Well Name: PERF	Well Location: T30N / R14W / SEC 35 / SESW / 36.765084 / -108.281459	County or Parish/State: SAN JUAN / NM
Well Number: 90	Type of Well: OTHER	Allottee or Tribe Name:
Lease Number: NMNM0206995	Unit or CA Name:	Unit or CA Number:
US Well Number: 300453017200S1	Operator: DUGAN PRODUCTION CORPORATION

Type of Submission: Notice of Intent

Type of Action: Plug and Abandonment

CONDITIONS OF APPROVAL

Planned P & A Wellbore Schematic

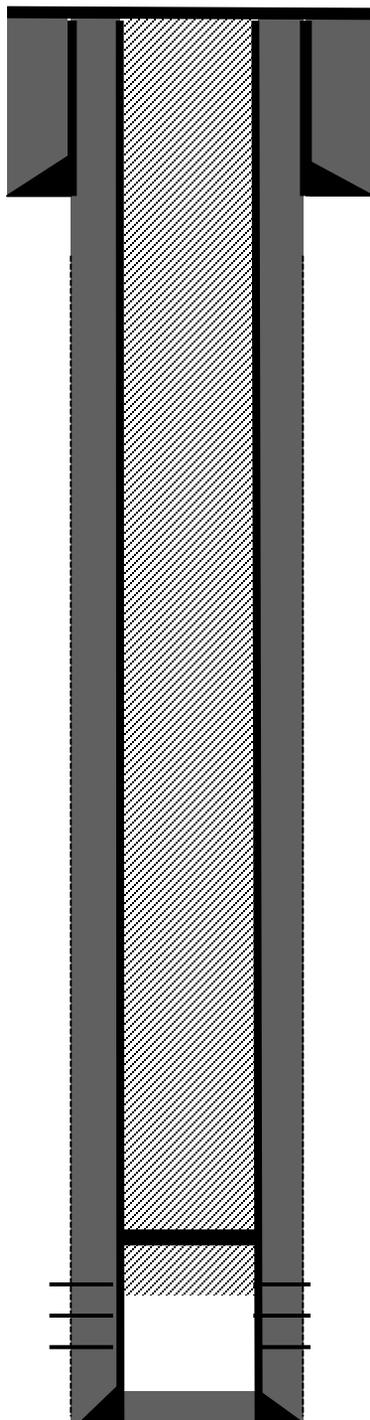
Created By	Condition	Condition Date
mkuehling	Notify NMOCD 24 hours prior to moving on - monitor string pressures daily report on subsequent - submit all logs prior to subsequent	3/25/2025
mkuehling	NMOCD agrees with BLM call on formation tops except on PC = 1104 - extend plug under retainer to 1154-	3/26/2025

**Set 4 1/2" CR @ 1032'. . Plug I, Inside 4 1/2" casing, CR at 1032',
100 sks, 115 Cu.ft, Pictured Cliffs-Fruitland-Kirtland-Surface,
0-1082'**
